Mr. J. N. DOUGLASS remarked that the Messrs. Stevenson were to be congratulated for having completed the work without loss of life or limb to any of the persons employed, and also for having adopted granite for the tower. No doubt the tower might have been constructed with wrought iron or cast iron, but, in doing so, little reduction would have been effected in the cost, while an annual outlay would have been involved for the preservation of the work, and there would have been a limit to its duration. The Author had furnished some interesting particulars relative to the heavy seas experienced at Dhu Heartach. The position of the rock and the nature of the soundings seaward were doubtless sufficient to account for heavy seas, but he did not consider there was evidence to show that heavier seas occurred there than at the Bishop or the Wolf rocks on the west coast of England, as might be expected by comparing the soundings. On the north-west, or most exposed side of the Bishop, at a distance of 4 miles, there was a depth of 50 fathoms, gradually shoaling to 30 fathoms close to the rock, which had a gradient to the westward of about 1 in 1. These were favourable conditions for heavy se

FIG. 1.

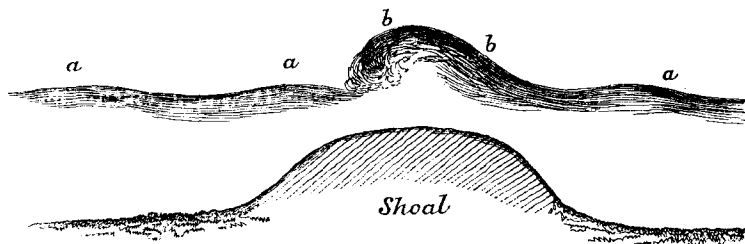
Sir JOHN COODE, while fully agreeing with the Author as to the importance to be attached to the configuration of the bottom in its effect upon the height of waves, did not think that the diagram quite bore out the view which had been put forward. The Dhu Heartach lighthouse was in 30 fathoms of water; the next contour was 40 fathoms, a difference of only 60 feet in about 5 miles, or 12 feet per mile. Such an inclination—1 in 440—was not, he thought, sufficient to affect the rise of the waves. He believed Mr. Longridge must have been misled by not distinguishing between undulations in deep and in shoal water. Of the difference between the two he had once had a good illustration. Looking seaward at

a point where his eye struck the horizon 4 miles off, the general configuration of the sea surface was a slight undulation, as at *a a a*; but at a point where there was a shoal, with 2 fathoms of water over it, the line was as at *b b* (Fig. 1). This would give some

idea of the effect of the gradual shoaling of the bottom upon the height of sea waves. He thought great credit was due to Messrs. Stevenson for the manner in which the work had been carried out under exceptional difficulties, and the more so that it had been executed without loss of life or injury to any individual engaged upon it.

Both Mr. Douglass and Sir John Coode seemed to have thought that it was the gradually sloping form of the bottom to which the Author attributed the peculiarly heavy action of the sea at Dhu Heartach. But this was not the case; it was to the submarine valley leading deep water up to the lighthouse, and increasing the height of the waves by its converging and comparatively precipitous sides, that the violent action was attributed. He had consulted the Admiralty charts before completing the Paper, and had found that neither the site of the Edystone, Bishop, Bell Rock, or Sker-vore lighthouses had any similar submarine feature open to the waves which assailed the towers on those rocks.
